Report: TES-DCS-20-05

Region of Waterloo
Transportation and Environmental Services
Design and Construction

Subject: Project Approval - King Street East, Highway 401 Overpass to Freeport Bridge and Sportsworld Drive, King Street East to Gateway Park Drive

Figure 1 – Recommended Design Concept Cross-section

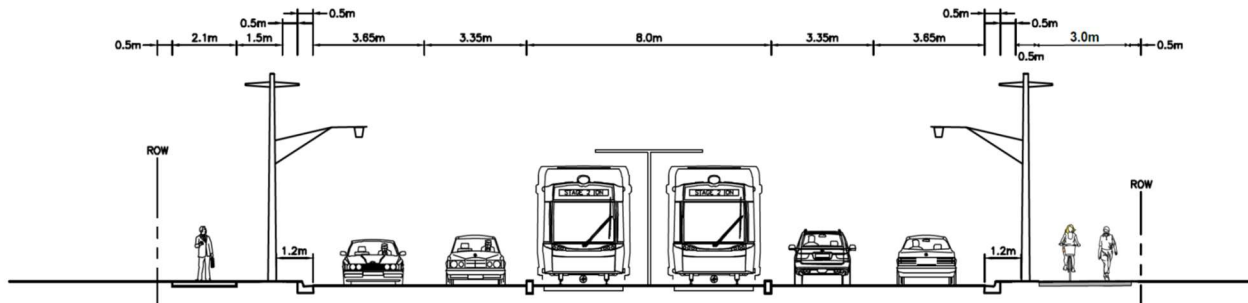
In consideration of the comments provided by the public at the PCC and the subsequent updated information provided to the Project Team, the Preliminary Design Concept has been refined. A typical cross-section of the Recommended Design Concept for King Street showing the proposed multi-use trail and central corridor for future use for Stage 2 ION is shown in Figure 1.
